EMERGENCY ALERT SERVICE BULLETIN

TIME LIMITS - MAINTENANCE CHECKS - Tail Rotor Hub

Check of the tail rotor hub body

HELICOPTER CONCERNED	NUMBER	Version(s)	
		Civil	Military
EC120	05A020	B

Figure 1

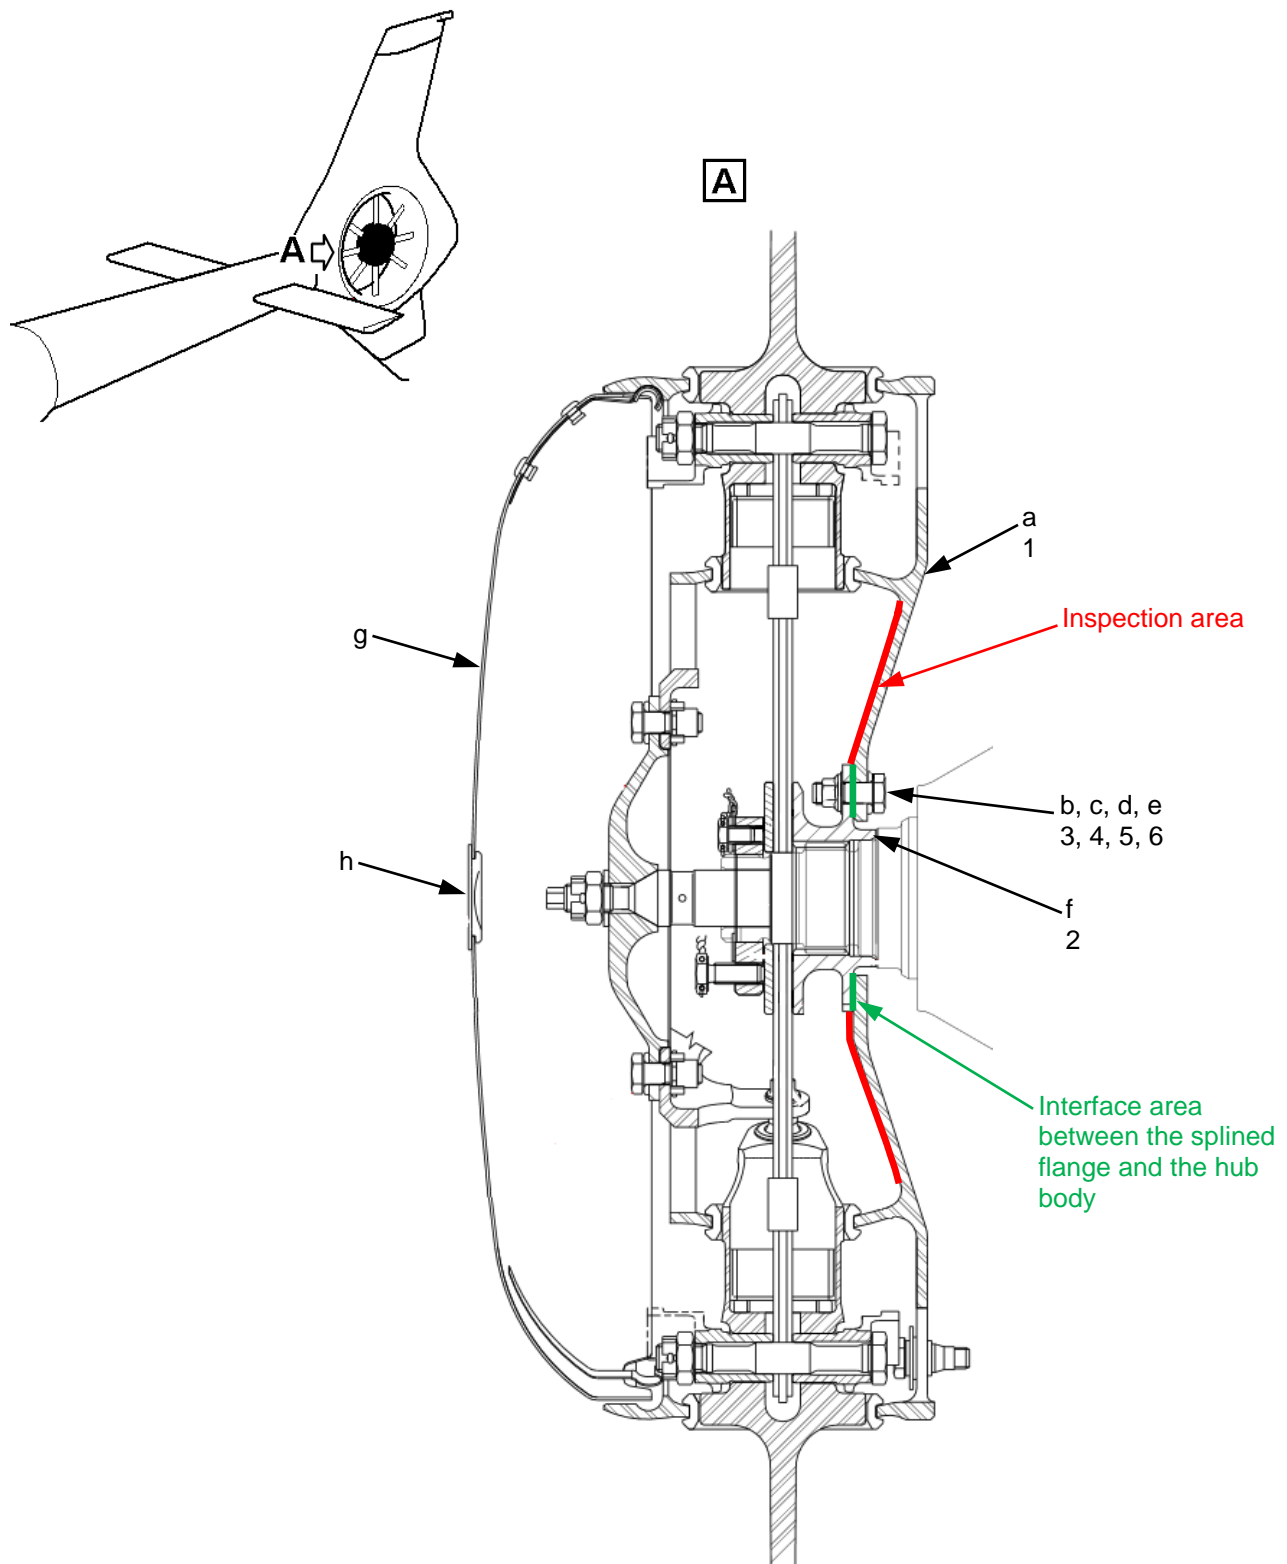
- Remove the fairing plug (h).
- Remove the fairing (g) (Detail A, Figure 1).
- If necessary, release the rotor brake.

- Perform a visual inspection of the hub body (a), (Figure 1).
 - . Using a light source and, if necessary, a mirror (zz) (e.g. dentist's mirror), make sure that there are no cracks in the hub body, in the inspection area defined as per [Figure 1](#).
- Turn the tail rotor by hand to check the entire inspection area defined as per Figure 1.
- Interpret the results as per [paragraph 1.E.2](#).

- Remove and discard the hub body (a), ([Figure 1](#)) as per Task 64-21-00, 4-3 (AMM).
- Discard the bolts (b), the washers (c) and (d) and the nuts (e).
- Install the hub body (1) as per Task 64-21-00, 4-4 (AMM) with bolts (3), washers (4) and (5) and nuts (6).

- Remove the splined flange (f) ([Figure 1](#)) as per Task 64-21-00, 4-3 (AMM).
- Install the splined flange (2) as per Task 64-21-00, 4-4 (AMM).
